Estes Park Campground at Mary's Lake Electrical & Water Distribution System Improvements Phase II

From: Zenda Smith, Campgrounds Manager
Date: February 2, 2022
Subject: Addendum #2
Pages: 12
To: All Plan Holders

The following questions have been submitted by prospective bidders and answers are provided below:

MIDWEST METALLIC EARTH BURIAL PEDESTAL
70A UNMETERED 120/240V 1PH3W UL LISTED

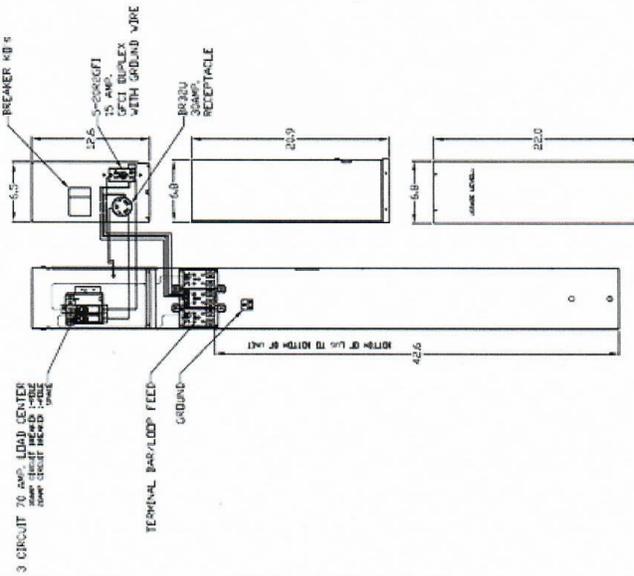
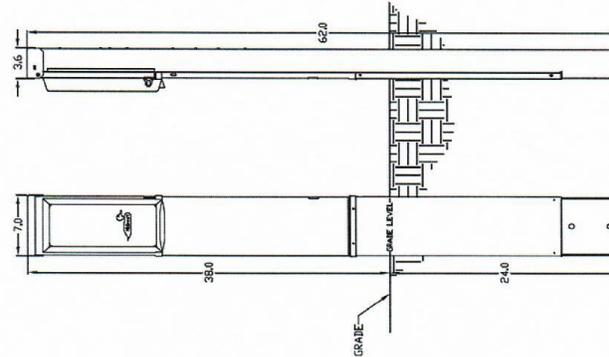
15. Please provide a spec sheet for the pedestal.

Exhibit attached on page 7 for Midwest part # U041CP6010 which may be the most easily sourced pedestal with shortest lead and delivery time. This is the 30/20A direct bury pedestal which will be procured by EVRPD.

NOTES: EARTH BURIAL POST

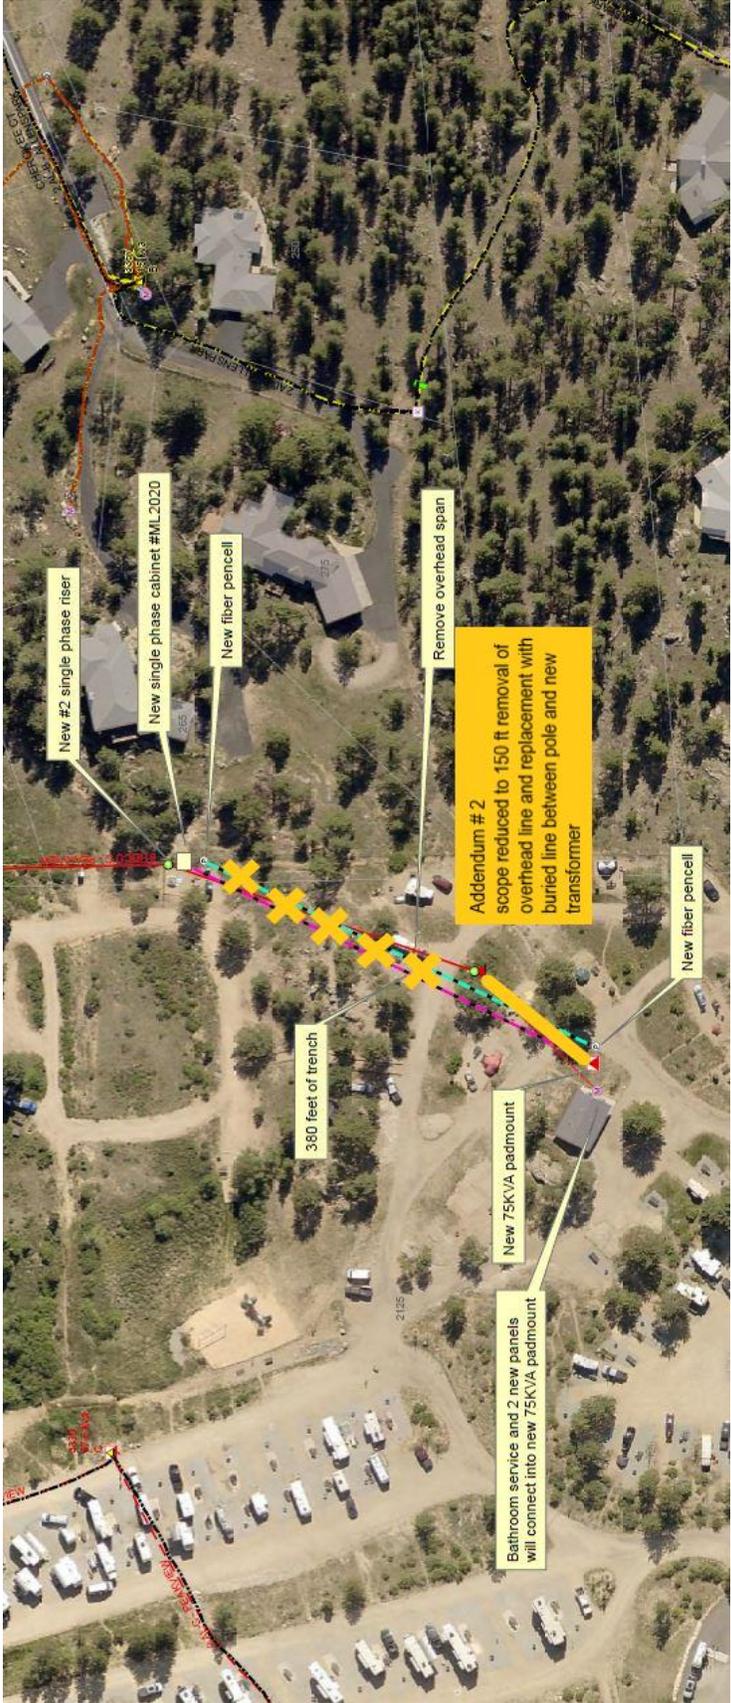
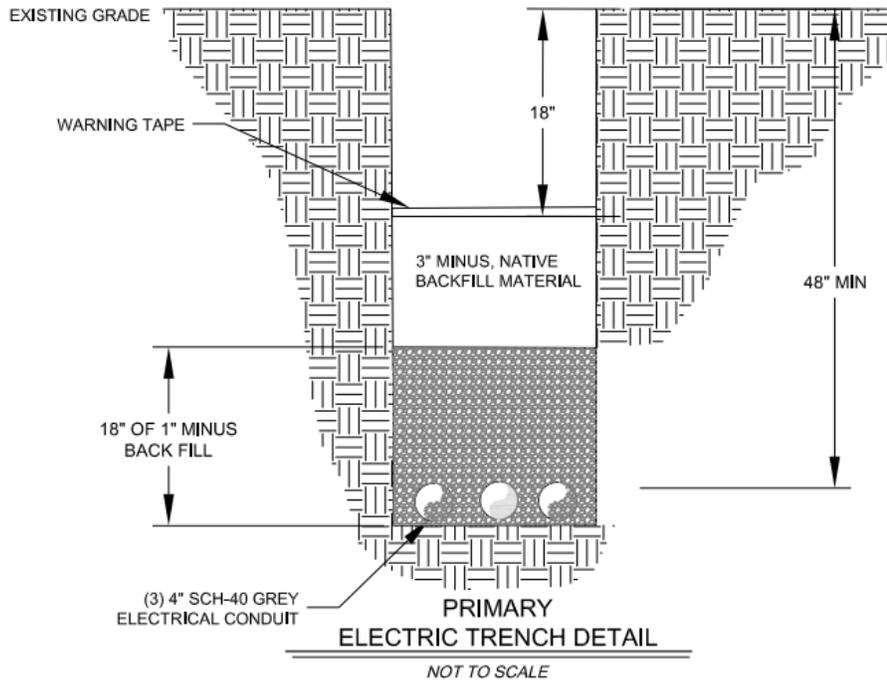
9. What is EP Power and Communication's scope of this project? Are they still providing, setting, and connecting the primary for the 75KVA pad mount transformer? Will they make all primary and secondary terminations in the transformer, with primary wiring?
Yes. NOTE: THE SCOPE OF WORK ADDED IN ADDENDUM #1 HAS CHANGED. Now, EP Power and Communication will be providing all materials with the exception of conduit which will be purchased by the Contractor. Power and Communications will provide the precast pad for the transformer. This will alleviate some issues with procurement. The length of the overhead removal and new direct burial has also been reduced. The Contractor only needs to bid 150 feet of trenching, labor, and 450 ft. plus sweeps of conduit from the shower house to the 1st pole (for 3 lines). 4" HDPE is an acceptable substitute for PVC and is listed as an option. See attached map on page 8, trench detail on page 9, and adjusted bid sheet on page 10. Disregard the bid sheet in Addendum #1.

ALL WORK IS TO BE COMPLETED PER THE "TOWN OF ESTES PARK POWER AND COMMUNICATION POLICY AND PROCEDURE" INCLUDING BUT NOT LIMITED TO:

3. TRENCH COVER ON CONDUIT OVER PRIMARY POWER SHALL BE 48" BELOW FINISHED GRADE.
4. ALL CONDUIT SHALL BE 4" SCH-40 GRAY ELECTRICAL PVC CONDUIT.
5. ALL CONDUIT SWEEPS SHALL NO LESS THAN A 3' RADIUS.
